CITY OF SACRAMENTO 1231 I Street, Sacramento, CA 95814

9908928

Site Address: 2813 57TH ST SAC

CITY OF SACRAMENTO DEPARTMENT OF NEIGHBORHOODS, PLANNING AND DEVELOPMENT SERVICES BUILDING INSPECTIONS DIVISIONS RESIDENTIAL PLAN CHECK

FIRST FLOOR PLAN

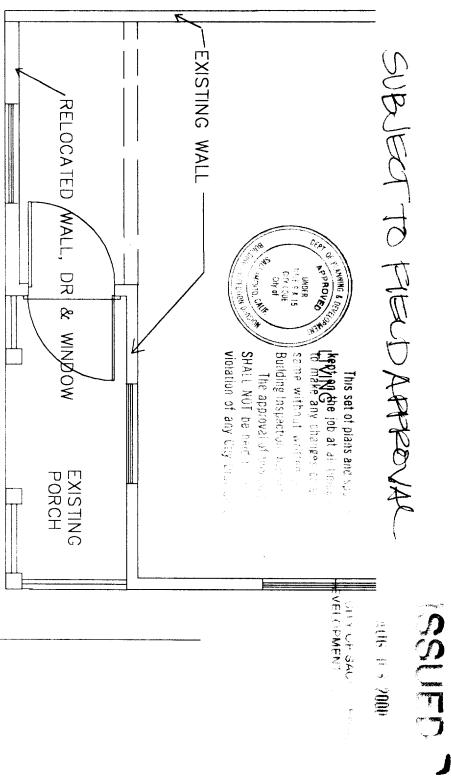
ADDENDUM to permit #9908928R
